CASE NO. NEPR-MI-2019-0009

**MOTION TO SUBMIT REVISED TECHNICAL BULLETIN REGARDING SMART
INVERTER SETTINGS SHEETS ISSUED BY LUMA**

SMART INVERTER SETTINGS SHEETS

September 11, 2024

Figure 2-2. Example Volt-Watt characteristics

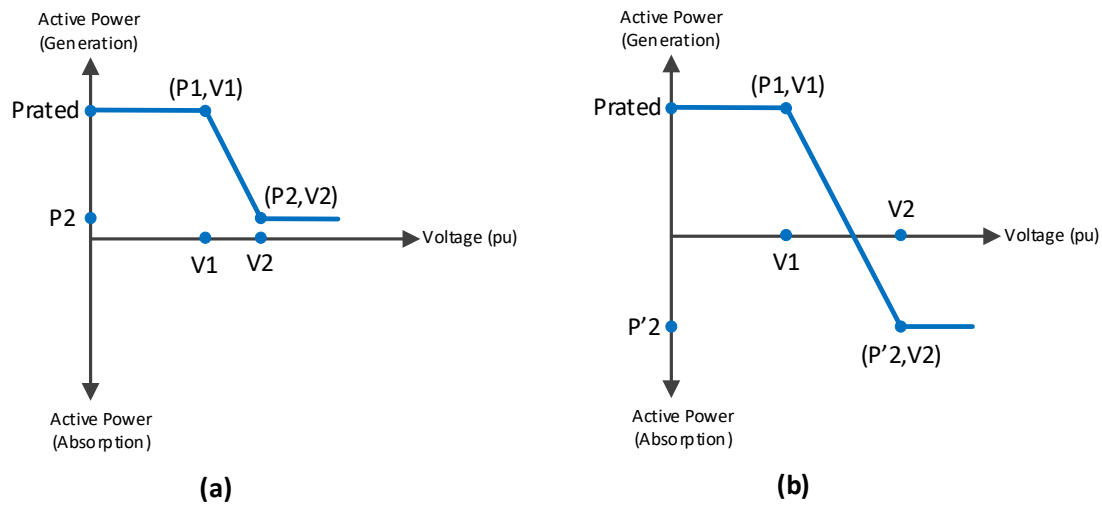
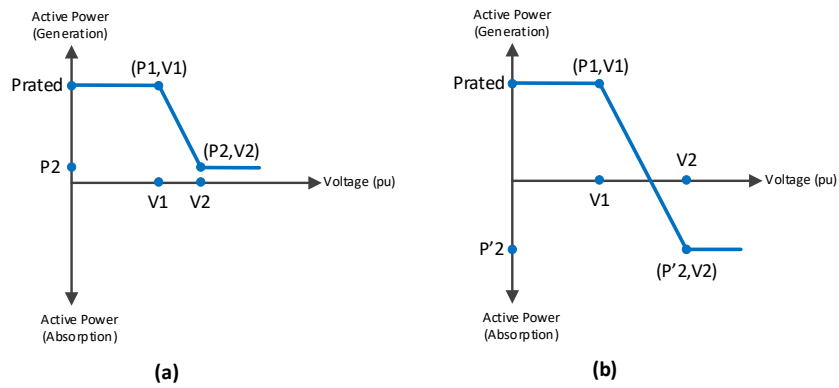
Table 2-7- Volt-Watt Settings – Deactivated ⁽³⁾

Table 2-7- Volt-Watt Settings – ~~Deactivated~~⁽³⁾ACTIVATED

⁽³⁾ ~~Deactivated for at least 6 months since deployment of this bulletin~~

Voltage-active power parameters	Default Settings	Ranges of allowable settings	
		Minimum	Maximum
V1	106% VN	105% VN	109% VN
P1	P_{rated}	NA	NA
V2	110% VN	$V1 + 1\% VN$	110% VN
P2 (applicable to DER that can only generate active power)	The lesser of $0.2 P_{rated}$ or $P_{min}^{(1)}$	P_{min}	P_{rated}
P'2 (applicable to DER that can generate and absorb active power)	0	0	$P'_{rated}^{(2)}$
Open-loop response time	10 sec	0.5 sec	60 sec

⁽¹⁾ P_{min} is the minimum active power output in p.u. of the DER rating (i.e., 1.0 p.u.).⁽²⁾ P'_{rated} is the maximum amount of active power that can be absorbed by the DER.⁽³⁾ Deactivated for at least 6 months since deployment of this bulletin
